EXHIBIT 1

GREENWAY BOUNDARY MAP AND PROJECT PLANS

MENDOTA GRASSMAN GREENWAY FLOOD MITIGATION AND RESTORATION DESIGN

PROPOSED GREENWAY TYPICAL SECTIONS

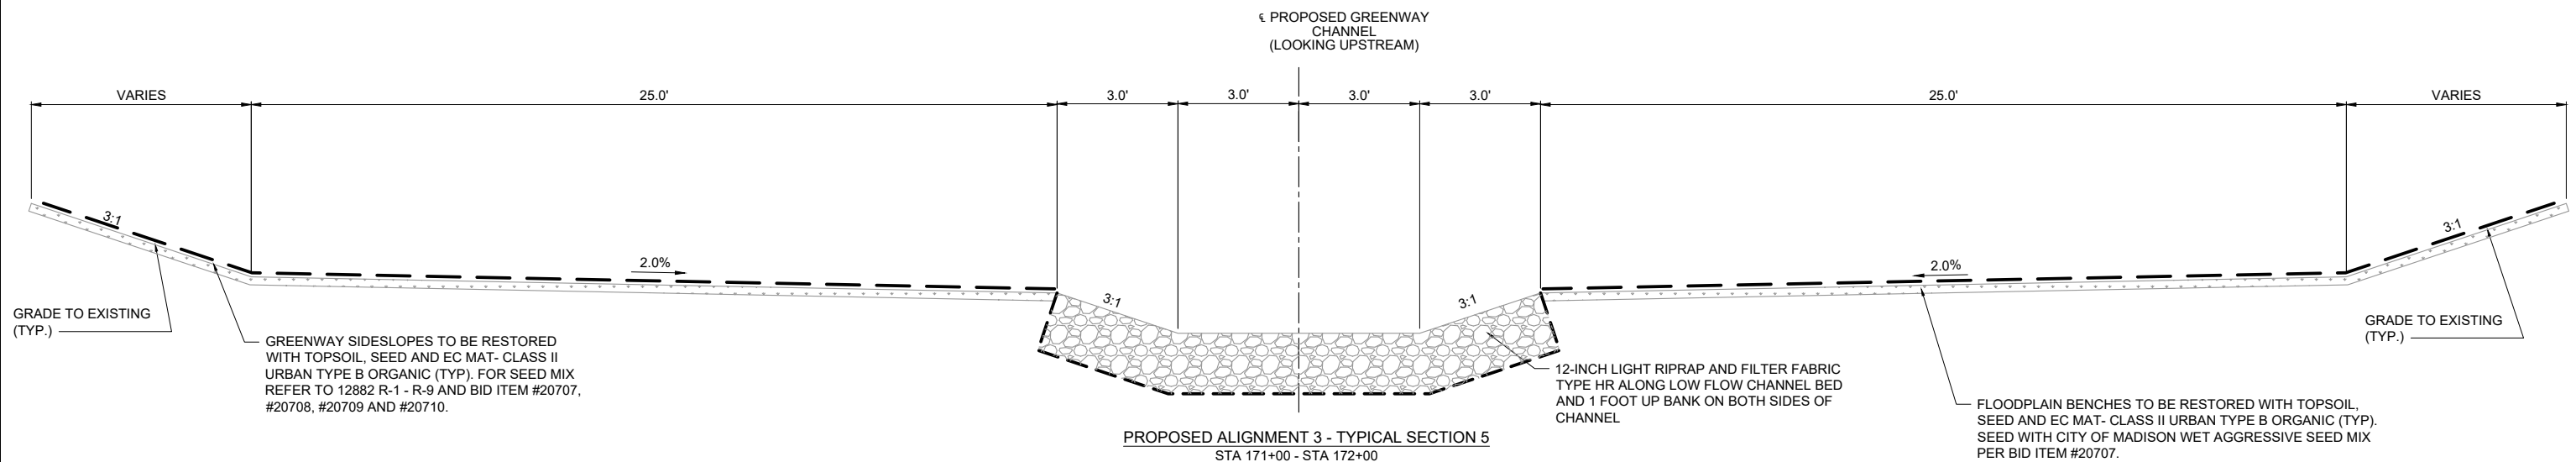
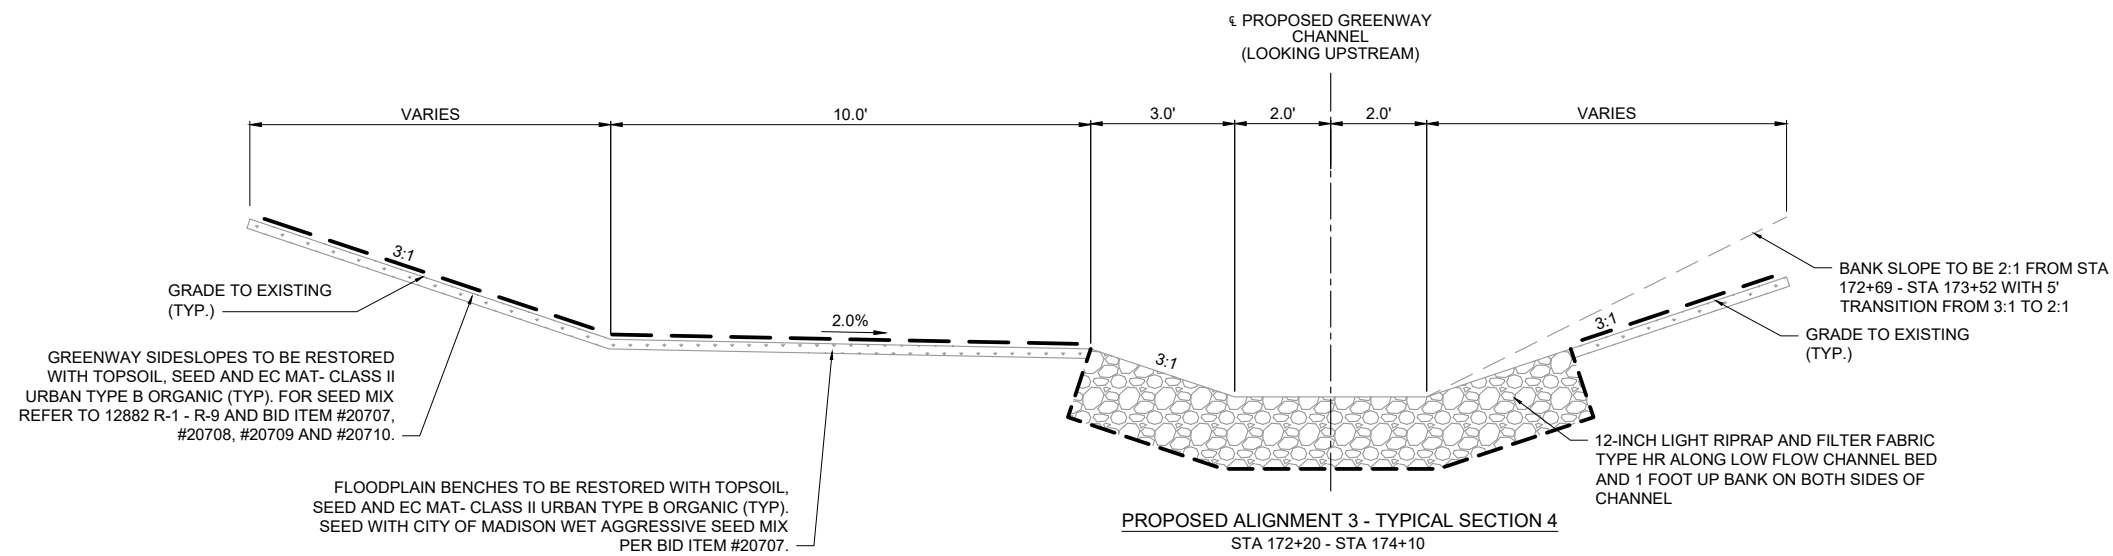
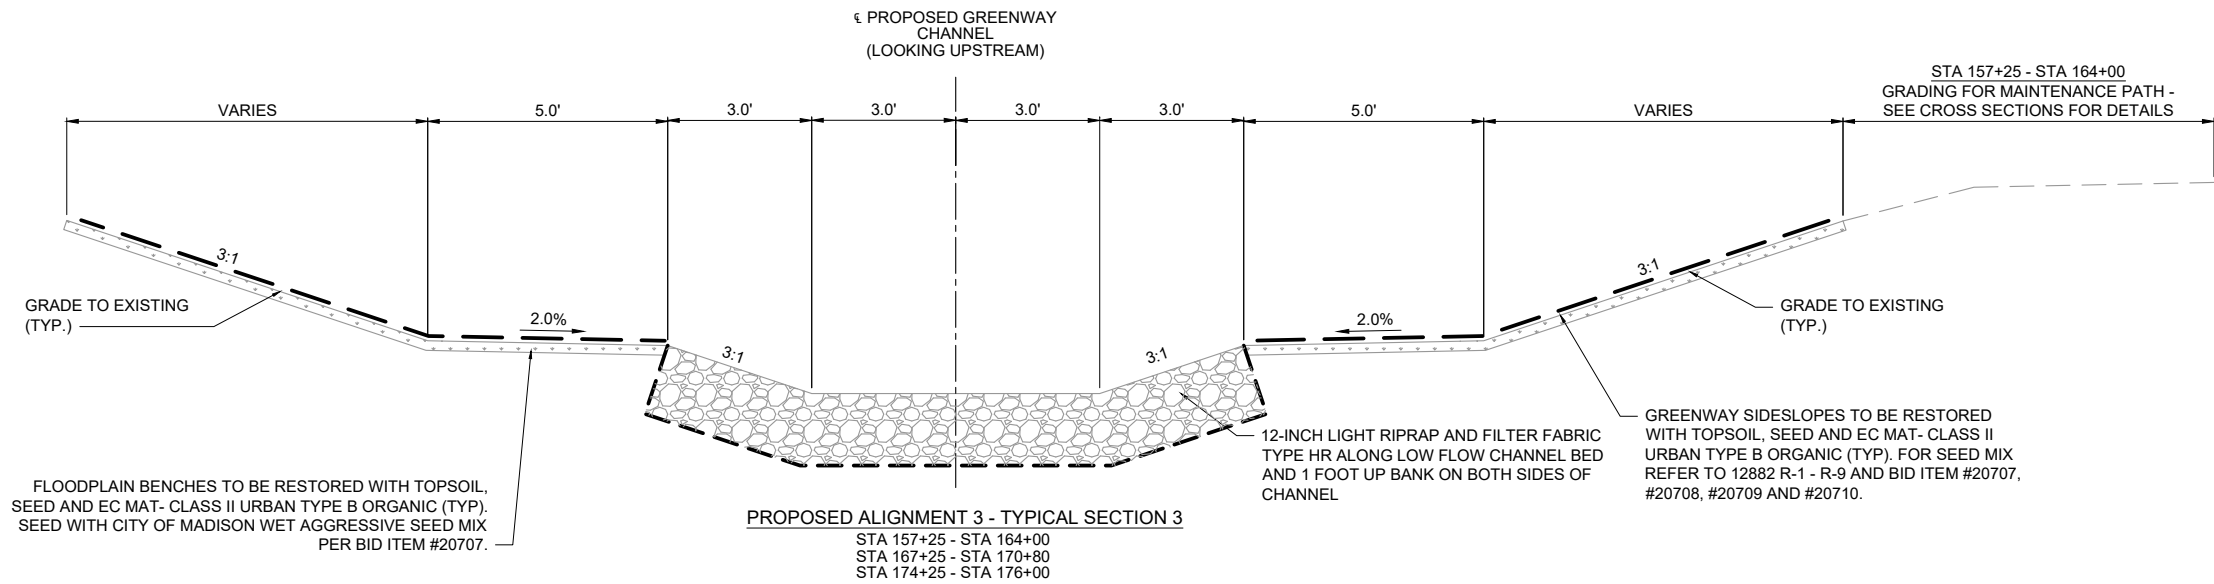
based on public feedback, we'd like to add 1" topsoil, and native path rush (need seed mix...we'll write a spec for it), and the EC Mat Class II Urban type B Organic

do we want to add another inch of crushed agg to cover the 3" geocell? (geocell specs say it should have 2" of agg on top, but we are trying to minimize the impact to the trees, so 1" feels like a good compromise)
